Analysis of Nuclear Metals Site
by
M. Rose Byrne and Richard Codell
Performance Assessment and Hydrology Branch
Division of Waste Management
Office of Nuclear Materials Safety and Safeguards

Introduction and Statement of Problem

Figure 12, RESSQ analysis of circulation among Service Water Wells, cooling pond, and upgradient recharge

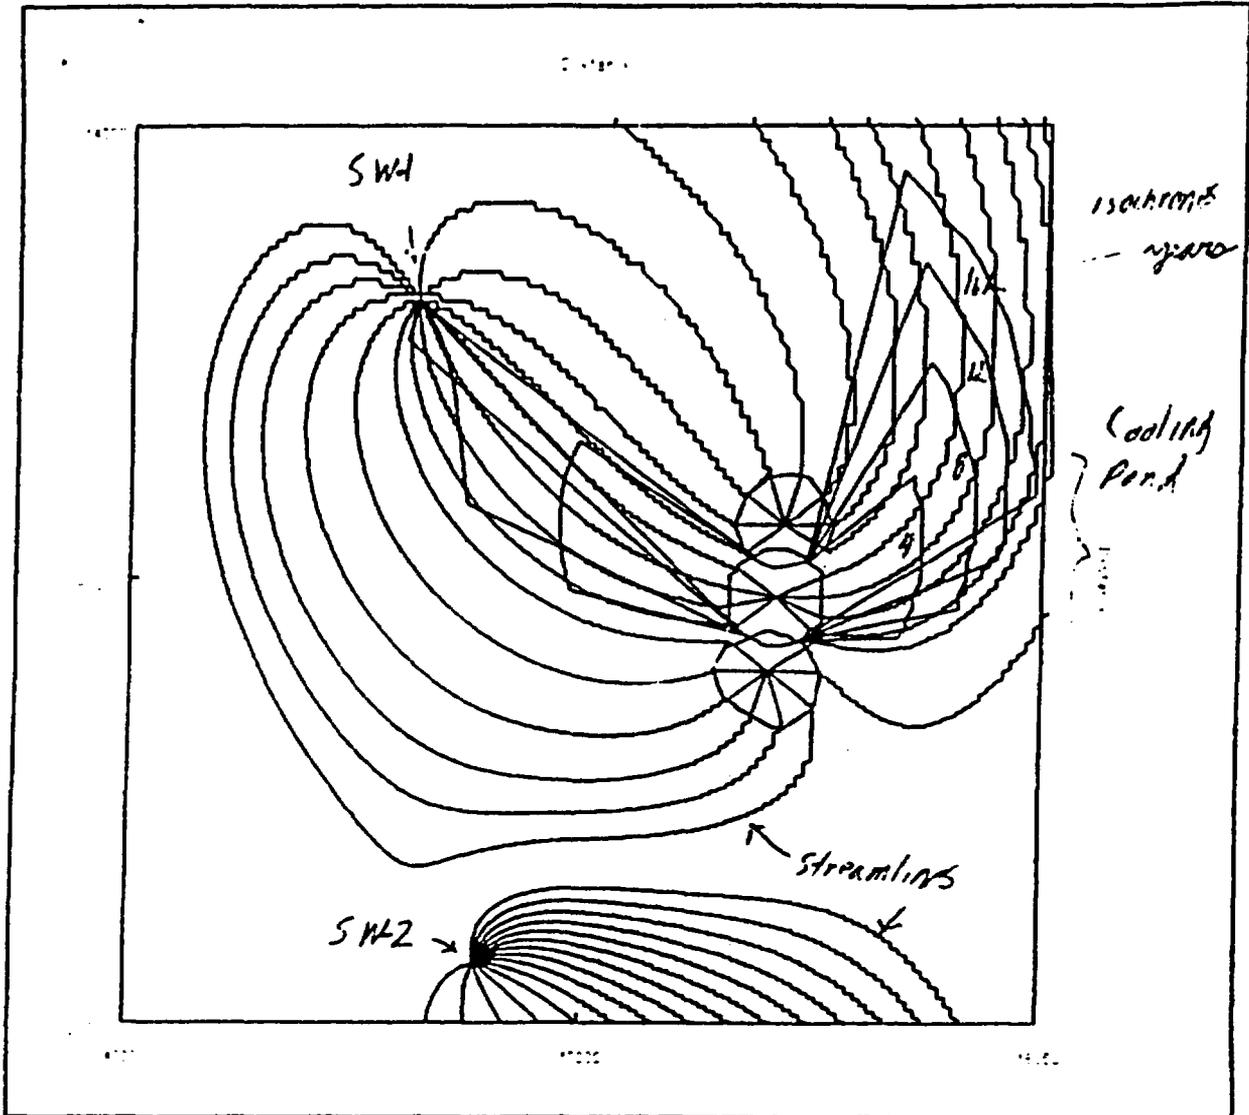
The flow net analyses suggest that groundwater following streamlines flowing under the holding basin are drawn into SW-2, at least in the case of the 0.5 ft/day regional groundwater flow rate. If this were the case, then contaminants leaching from the holding basin would reach the cooling pond relatively quickly. Recharge from the cooling pond is largely captured by SW-1, with the remainder traveling to the river. The flow net for the 1.0 ft/day regional groundwater flow is similar, but there would be less of the contaminants drawn into SW-2. There appears to be no recharge from the river to SW-1 in either case. The circulation between the service water wells and the cooling pond is the probable transport mechanism for contaminated groundwater between the holding basin and the cooling pond and all groundwater between them (This model appears to be borne out by correlation analyses reported in the next section). The circulation between SW-1, SW-2 and the cooling pond also serves as an untreated "pump and treat" operation, which at the very least is diluting the uranium concentrations to lower levels than found in SW-2. It does not appear likely that the uranium in the holding basin would have reached well SW-1 directly by natural gradient flow alone because of its high retardation in the soil. The fate of the uranium plume after shutdown of the pumps is uncertain. It is possible that after decommissioning the site, existing groundwater contamination would migrate at higher concentrations than is now the case because the dilution mechanism would be lost.

We are also concerned about the potential for migration of uranium once the pumping of cooling water ceases and the gradients in the region of the plant return to normal. We believe that the pumps may be in effect reducing the groundwater concentrations by dilution and recirculation. We would like to investigate whether cessation of pumping will remove a beneficial, though unintended feature of plant operation. We further would like to ask if cooling water pumping should be replaced by another process such as pump-and-treat or in-situ fixation to comply with environmental standards for unrestricted release of the site.
